## Notice for change in CPU board (U-X type)

件名	CPU 基板変更の お知らせ (U-X 形)	発行日付	2022年10月6日
		〒819-0192 福岡県福岡市西区今宿東一丁目1番1号 三菱電機 FA 産業機器株式会社 TEL 092-805-3400

### 6. Appearance of CPU board

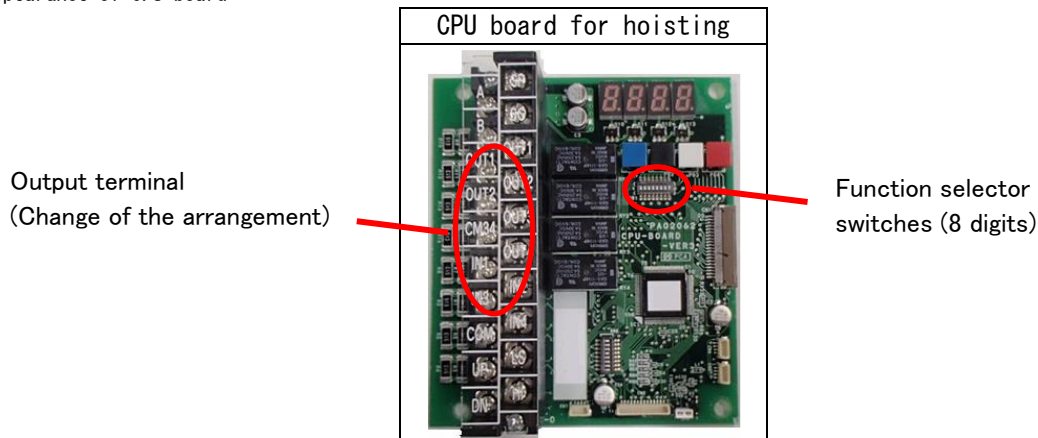
5. Changed points and Points to be noted
  - (1) The arrangement of output terminal is changed  
The change of wiring is necessary When replacing the CPU board.  
Please refer to the instruction manual for details.

- (2) The Function selector switches are changed from 4 digits to 8 digits.  
In the case of Hoist products, the Function selector switches are set at the time of shipment from the factory. However, it is necessary to set the Function selector switches when replacing the CPU board. Regarding setting method, please refer to the instruction manual. The hoist may be unable to be operated if the Function selector switches are not correctly set.

- (3) The setting range of operation frequency is changed.

Before change	After change
Frequency of low hoisting speed	9~30Hz	9~60Hz
Frequency of low lowering speed	Less than 3t : 6~20Hz 5t or more : 6~ 9Hz	6~9Hz

- (4) There is no change in operation and mounting dimensions.
